38 Walmer Rd.

“Link Facade” Memo

RE: Proposed Redevelopment Scheme by TAS
at 38 Walmer Road.

38 WALMER ROAD SETTLEMENT OFFER **R1**

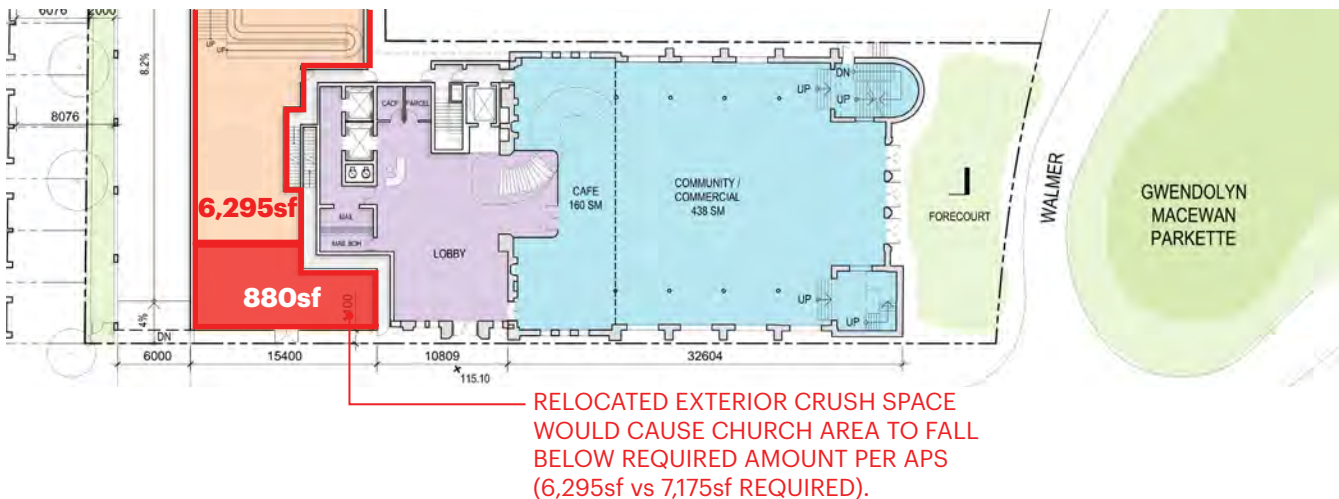
The “Link Façade” in its current location does not allow for a required Church exterior “crush space”.

1.1. Exterior crush space along Lowther is required for safe exiting of up to 300-600 people. The constrained sidewalk condition at Lowther is unable to safely accommodate upwards of 600 people.

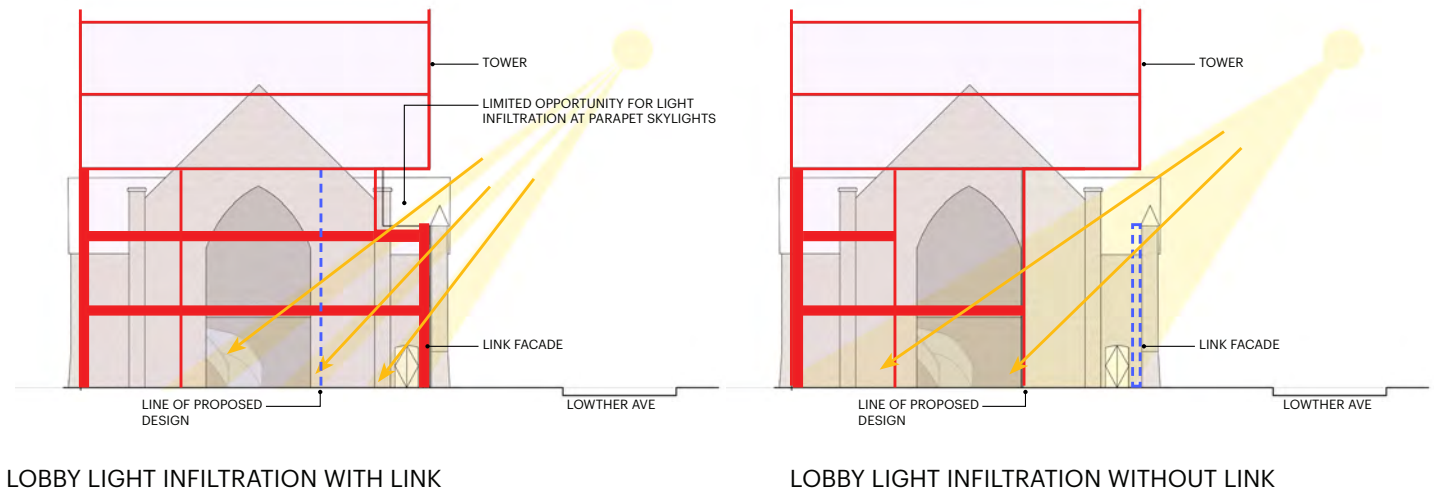
The “Link Façade” in its current location would create an undesirable deep lobby condition with limited opportunity for daylighting.

2.1. By keeping the “Link Façade” in its current location, the shared community / residential lobby would become very deep. Even with enlarged window openings, daylight is limited through the masonry facade.

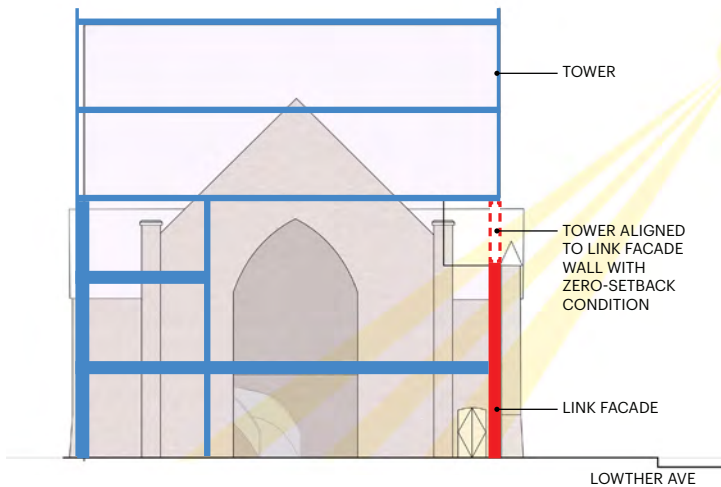
Retention of the “Link Façade” would render infeasible the proposal to fully expose the central arch opening which currently houses the organ pipes on the west elevation of the Sanctuary. If the link facade is retained, two options are available:

3.1. Option 1: Align the Link Façade with the tower face for vertical structural support, eliminating an articulated reveal.

GROUND FLOOR WITHOUT LINK: Exit into court.

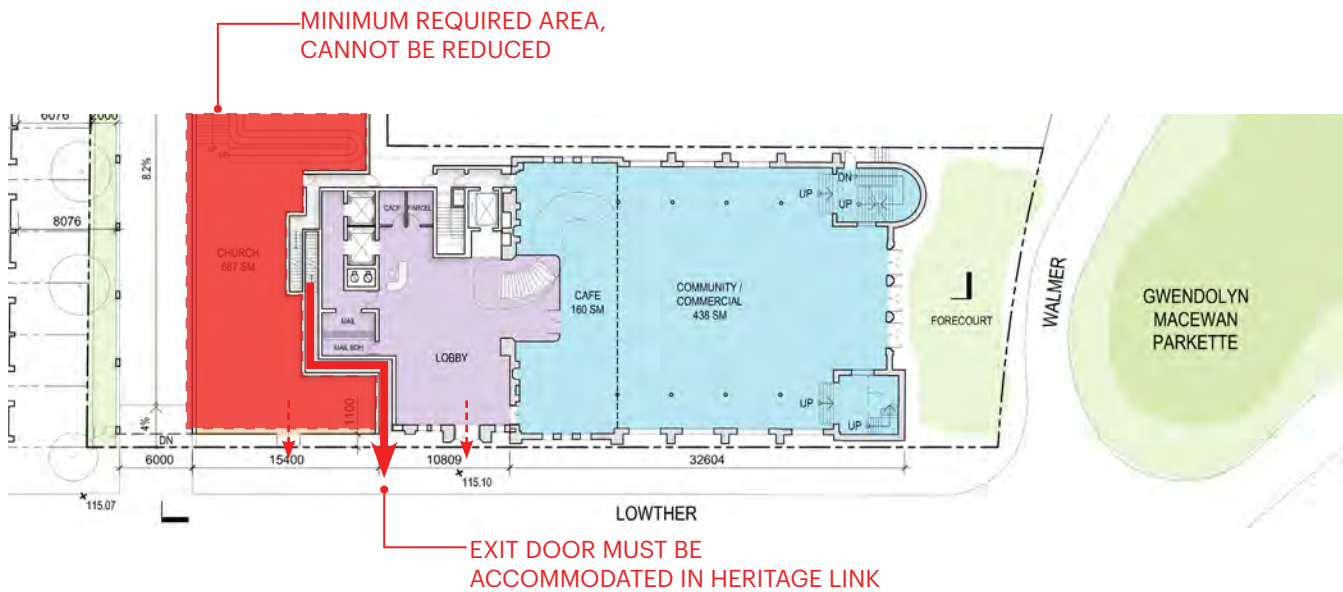
4.1. Per OBC requirements, the proposed development requires one protected exit leading from the residential tower at the Lowther frontage. In the current design, this exit opens into the proposed “Court”.

4.2. If the Link façade is retained, this exit pathway would have to be extended south and a new exit door would be needed in the “Link Façade”. The required exit door width is wider than the existing window openings and would therefore require the existing western-most pair of windows to be infilled.

GROUND FLOOR

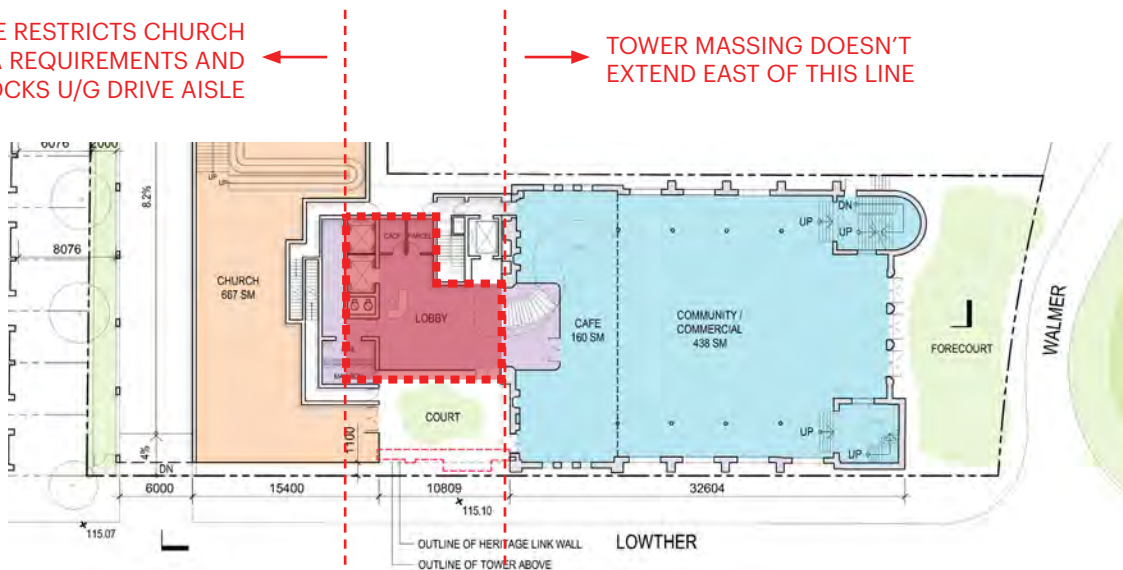
The proposed program arrangement cannot be reorganized to accommodate retention of the “Link Façade”.

7.1. The proposed program arrangement is determined by the location of the tower core.

7.2. The tower core cannot be moved, as this would interfere with the below-grade parking / loading area, the required WRBC ground floor area, and the requirement to retain the existing sanctuary building.

TOWER CORE RESTRICTS CHURCH
APS AREA REQUIREMENTS AND
BLOCKS U/G DRIVE AISLE

TOWER MASSING DOESN'T
EXTEND EAST OF THIS LINE
